ADDENDUM NUMBER 03

PROJECT: Enterprise Generator Replacements

OWASA CIP NUMBER: 378-14

OWNER: ORANGE WATER AND SEWER AUTHORITY

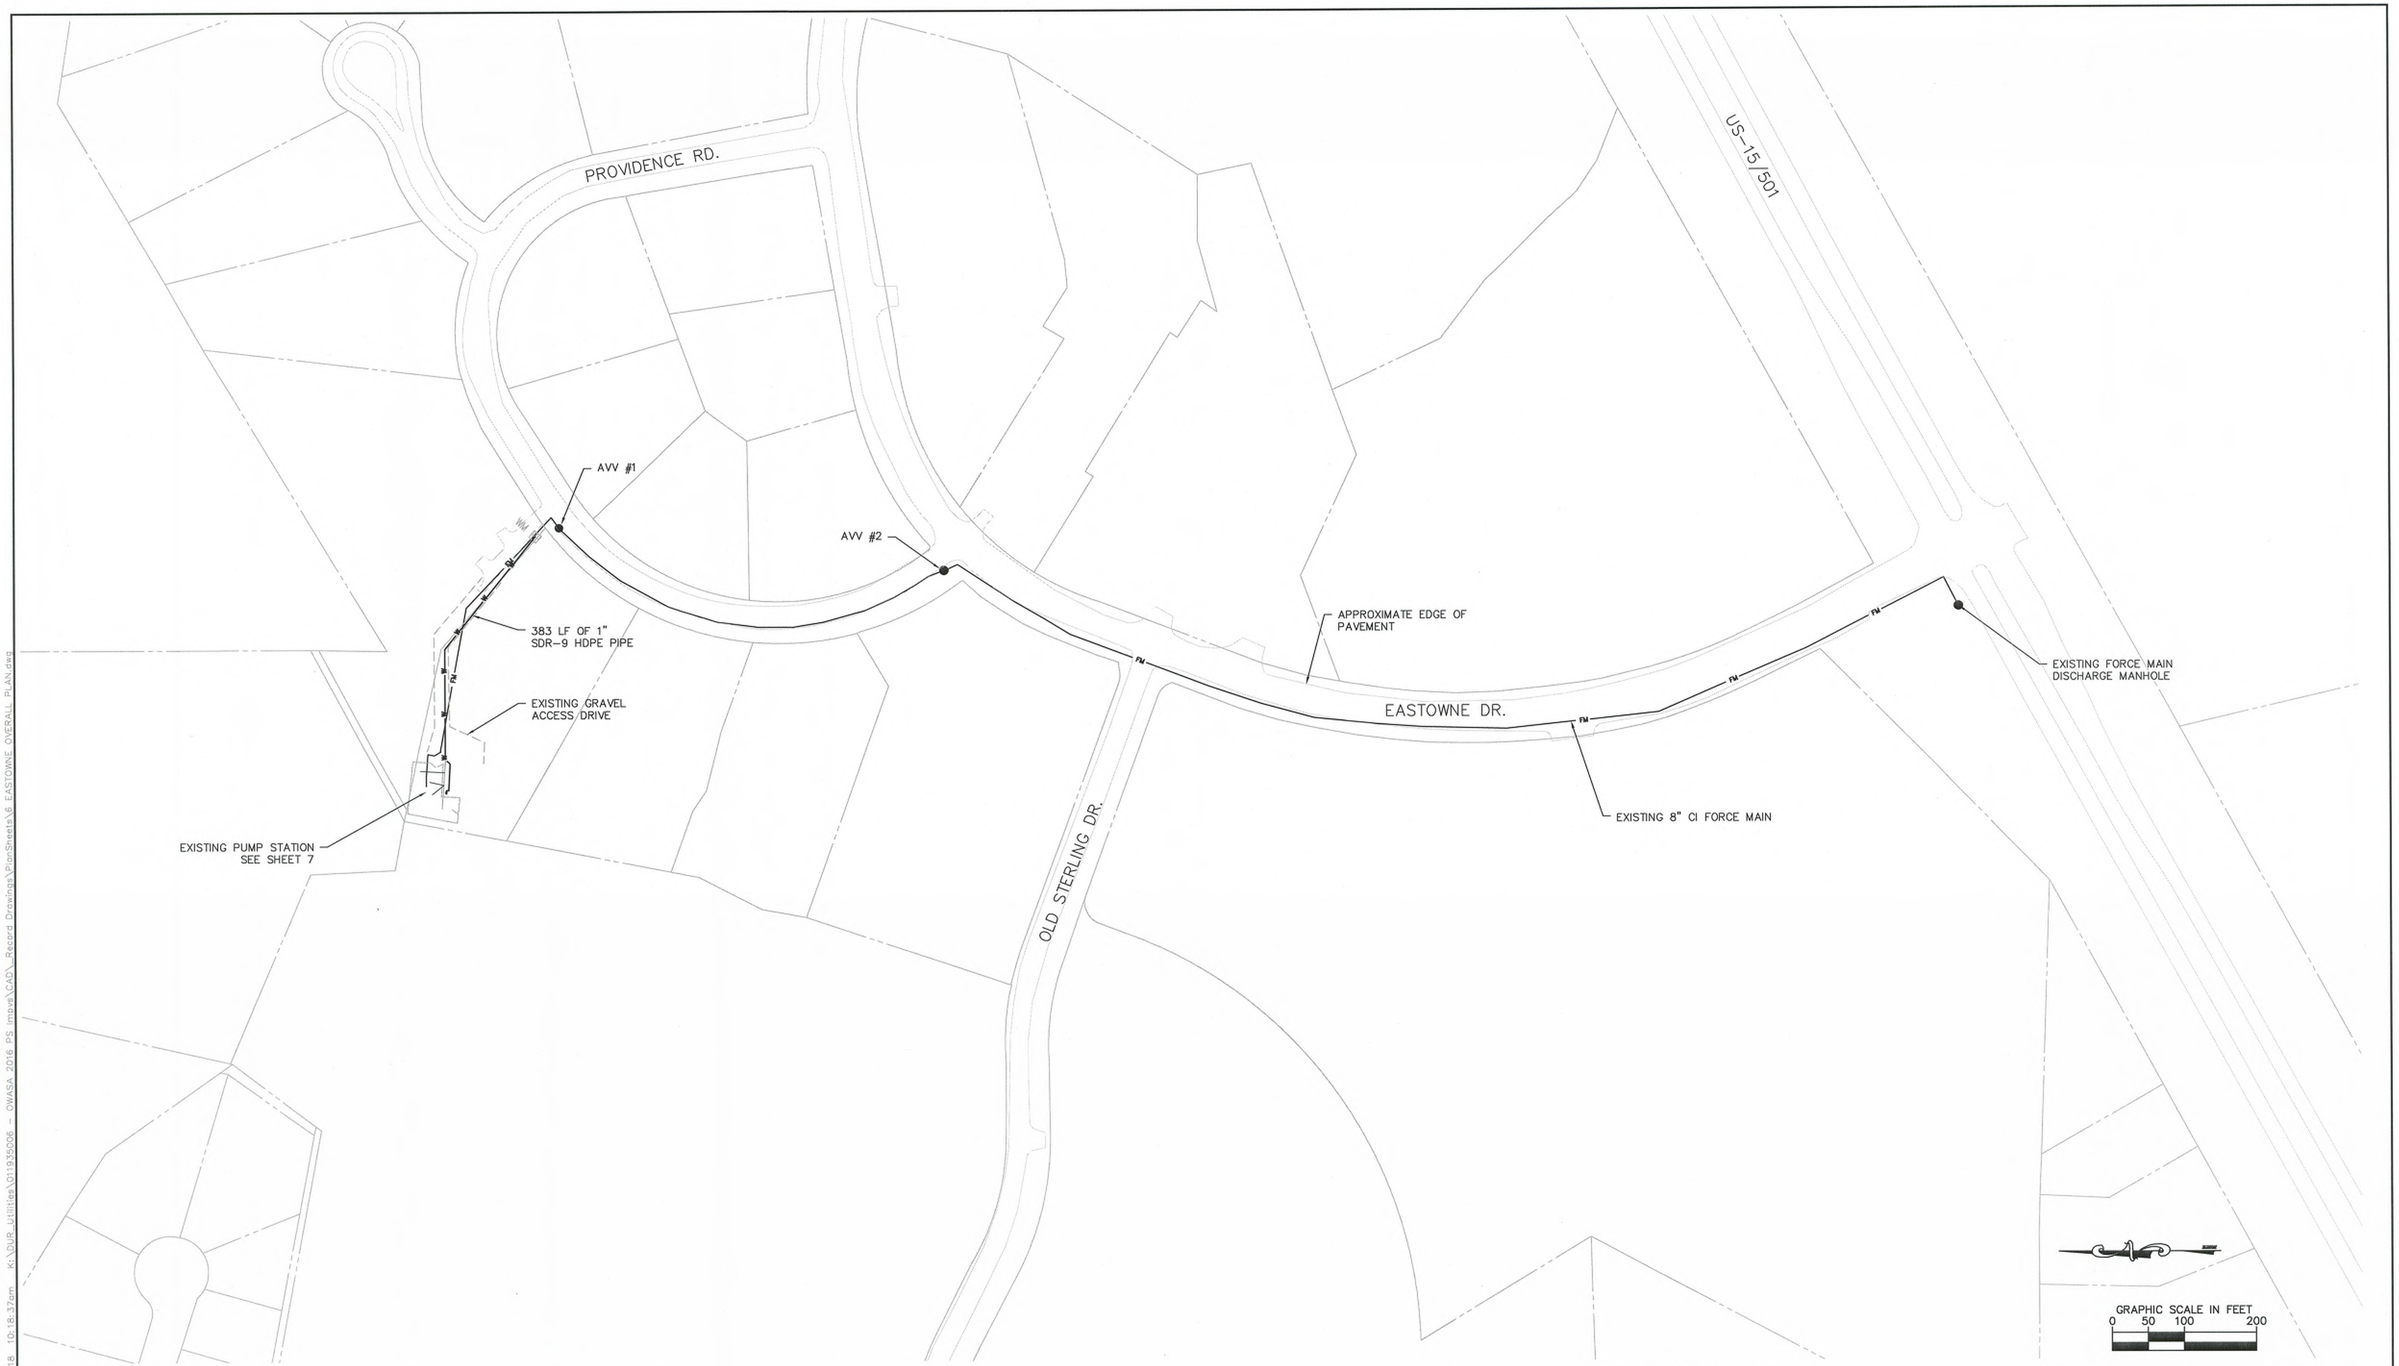
- *See attached PS Site Layout sheet from the 2025 OWASA manual that indicates Gen enclosures should be painted green by the Mfg and an 8" gen pad. This also indicates a wood rack (detail 539.05) be used for service equipment, which seems obsolete.* **See above about the 2025 Design Manual. No wood racks are acceptable.**
